**City of Portland, Oregon**  
**Bureau of Development Services**  
**Land Use Services**  
FROM CONCEPT TO CONSTRUCTION

## **NOTICE OF A TYPE II DECISION ON A PROPOSAL IN YOUR NEIGHBORHOOD**

### **CASE FILE NUMBER: LU 15-188191 AD** ***HEIGHT ADJUSTMENT FOR NEW MULTI-DWELLING DEVELOPMENT***

**Site Address:** 1915 SE 12TH AVE

CASE NO. LA 15-188191 AD  
EXHIBIT C.2

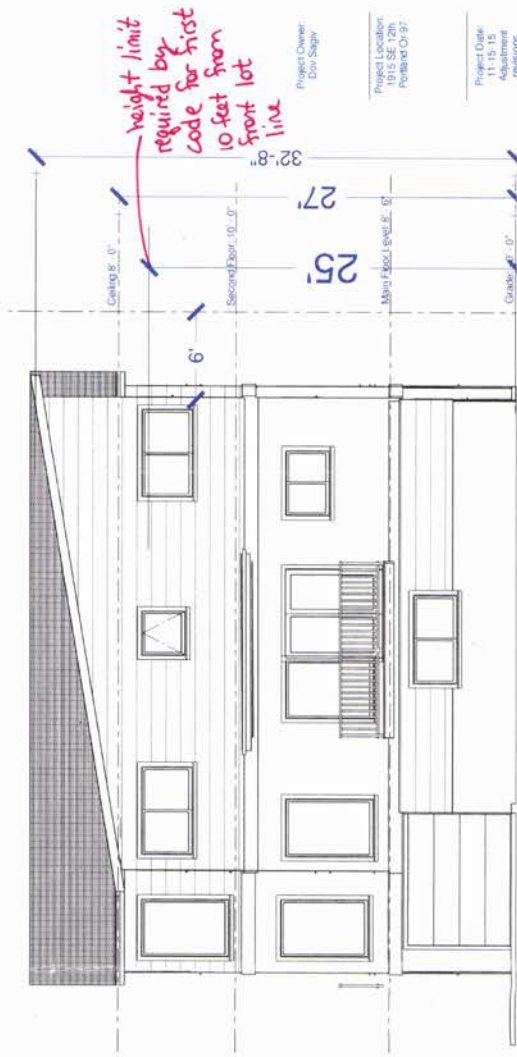
Given the orientation of the shed roof, the highest point of the building is located 6 feet from the front property line and is 30 percent taller than allowed,. While the applicant

has shifted the building back slightly, from 3 feet to 6 feet, the building has not changed its shed roof form with the highest point at the north end of the building, nor has it changed its orientation (which is currently oriented away from the street, toward the side lot line and the drive aisle). The design creates a condition that maximizes the impact of the additional height on the neighbors and in the front of the property.

The development is designed with no entrances on the street-facing façade of the front building. There is one small slider window on the first story of the front building, opening to the garage. Garages make up the first story of each of the buildings, with each unit of the development granted a generous 2-car garage measuring 475 square feet on the interior. Access to the living spaces is provided through an open stairway between each garage to a second story. This lack of connection with the street and the emphasis on vehicle areas in the design are not consistent with all of the original buildings along SE 12<sup>th</sup> Avenue and does nothing to establish a relationship between other residences and the proposed buildings.

A second-story balcony with sliding glass doors on the front façade was added in response to staff's concerns regarding lack of connection with the street. However, given the mature street trees across SE 12<sup>th</sup> Ave., this balcony will not result in a reduction of privacy on nearby lots.

In the latest iteration of plans, a pair of single-hung windows on the front façade, opening into the garage, were removed and replaced by a smaller slider-style window into the garage at a higher level. It is not clear why a smaller window would be preferred in this area where there is an issue with a lack of visual connections with the street. Larger windows would not impact privacy on this level, for residents at the subject site or for adjacent properties.

**Findings:** The impacts of allowing this development to be built 30% taller than the maximum height limit of 25 feet at 6 feet from the front property line include excessive bulk and massing close to the property line; the flat façade (as opposed to a tiered transition from public to private realm); location of vehicle area throughout the ground floor, rather than activated living space; and the building's orientation away from the street lot line, with no entrance and only a small slider window on the first story facing the street.

These changes are insufficient to overcome the impacts created by the increased massing in the first 10 feet of the site, which are compounded by the impacts of orienting the front building away from the street. The resulting front façade is massive enough to overwhelm the streetscape in this historic area where the existing development pattern includes strong connections to the pedestrian realm by main entrances oriented to the street, steps, porches, and other similar transitions from public to private space.

No building sections are provided, and the materials are not identified. One way to mitigate against a taller building is to create more visual interest in the pedestrian environment. Often visual interest can be created through using a higher quality of materials in the windows, siding, trim, etc.; recessing the windows and doors into the

wall plane more deeply to increase the “punch” and the change in plane; and using thicker siding material with greater shadow lines more consistent with historic materials seen in Ladd’s Addition across the street. The information provided does not indicate whether any of these steps have been taken, but it does not appear from the elevations or the renderings that they have. Given the lack of pedestrian entryway and the limited windows on the front façade at ground level, and the garages making up the entire first story of both buildings, visual interest at the ground level is minimal.
